Santa Monica - Malibu Unified School District
**Phase 3 - Gold Gymnasium
& Exploration Building**

Board Approval Presentation
March 22, 2022

V.E. Updates

V.E. Updates

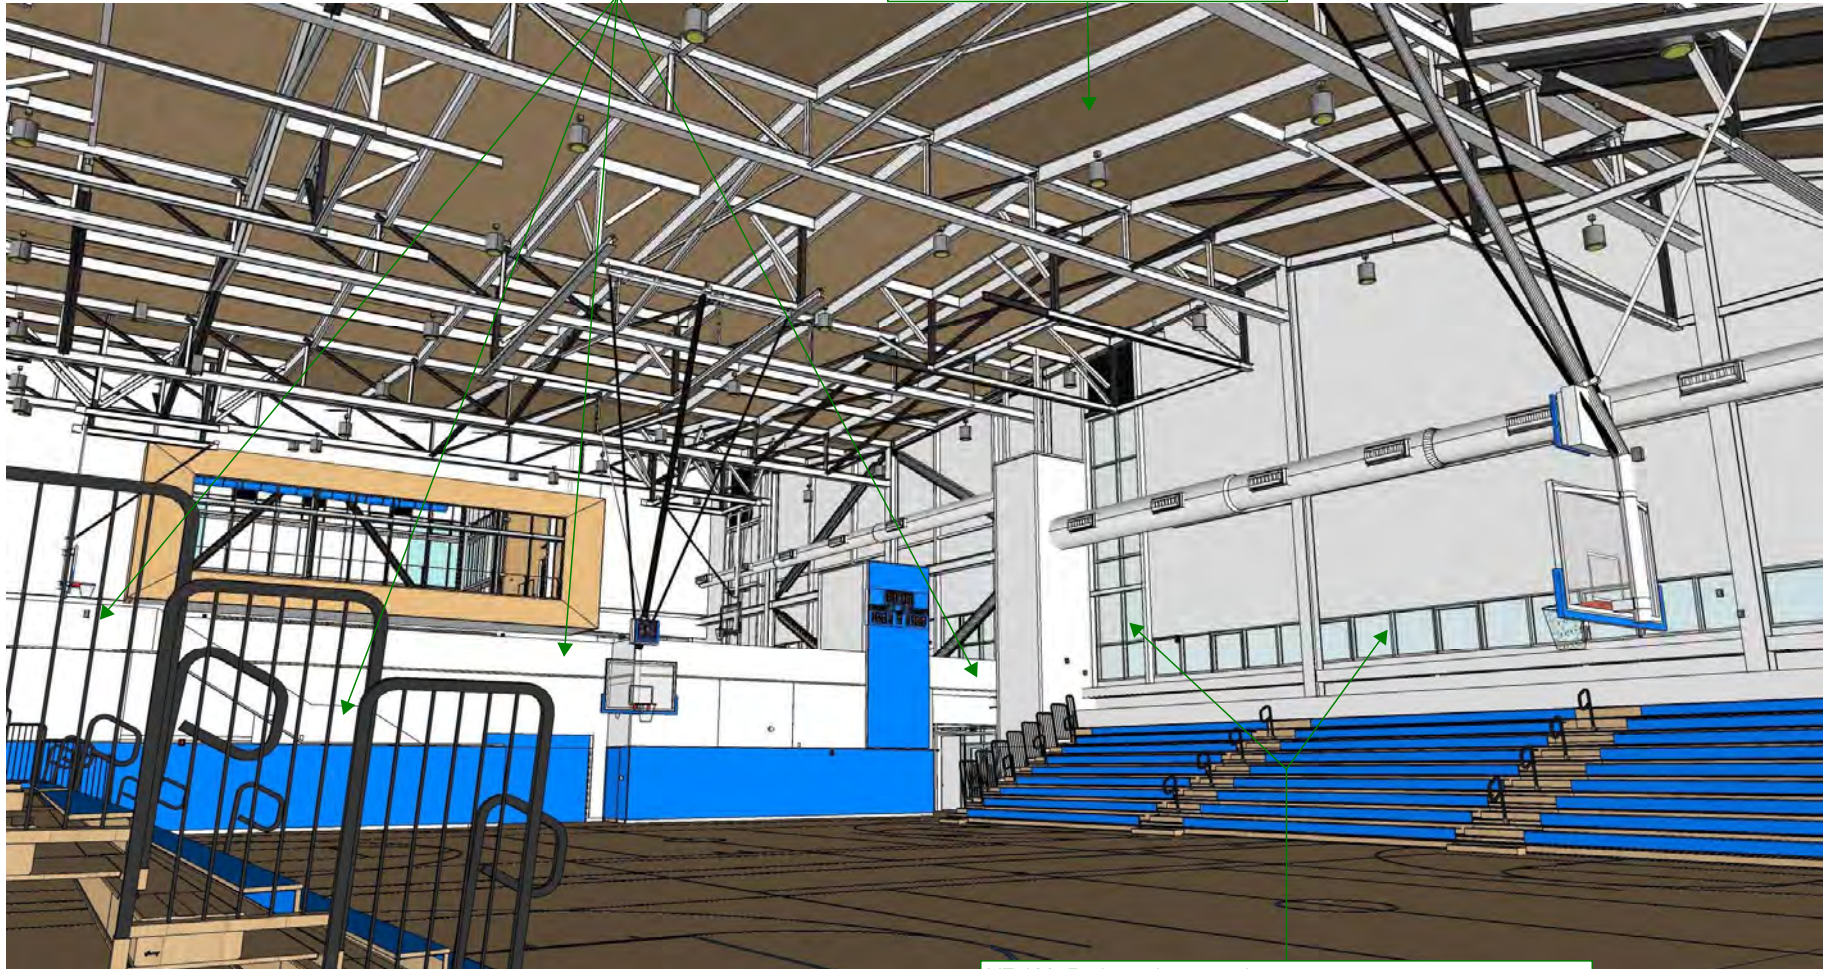
Solid wall in lieu of picket guardrail.

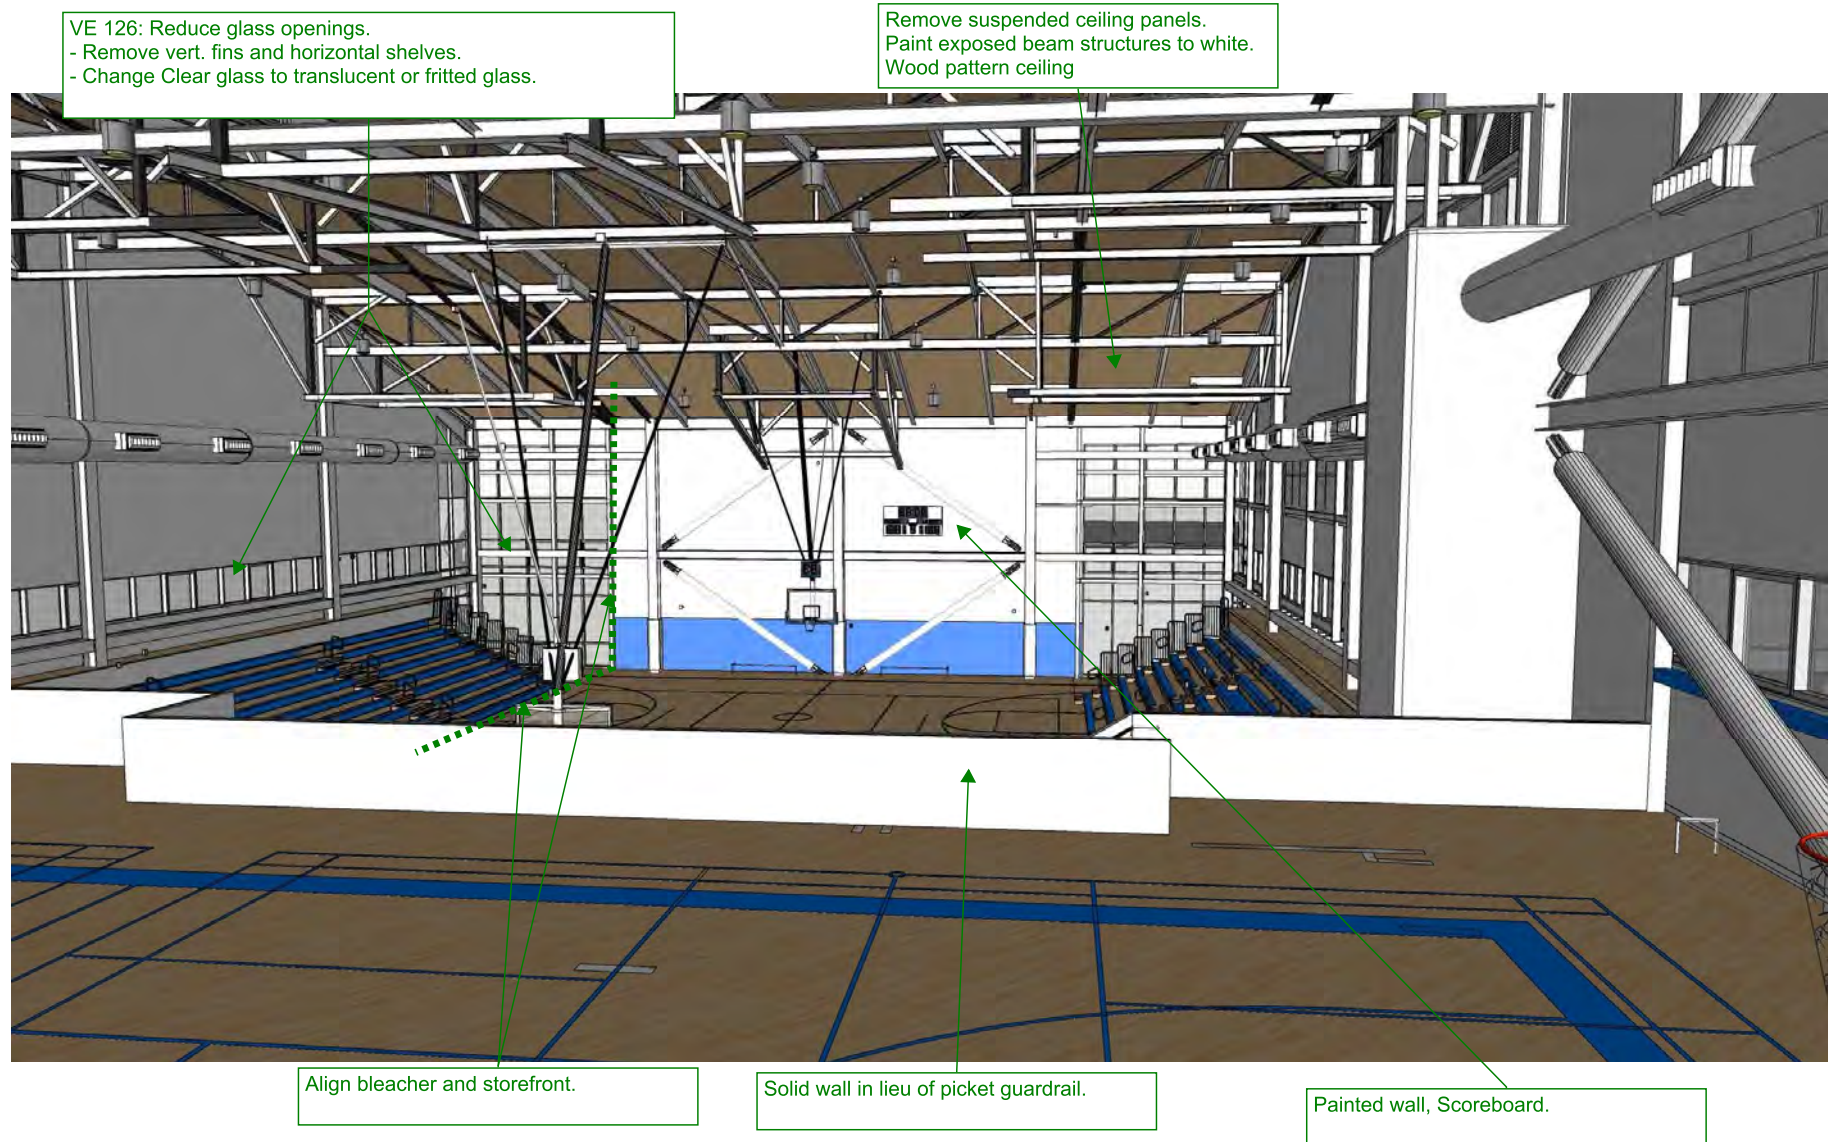
Remove suspended ceiling panels.
Paint exposed beam structures to white.
Wood pattern ceiling

VE 126: Reduce glass openings.
- Remove vert. fins and horizontal shelves.
- Change Clear glass to translucent or fritted glass.
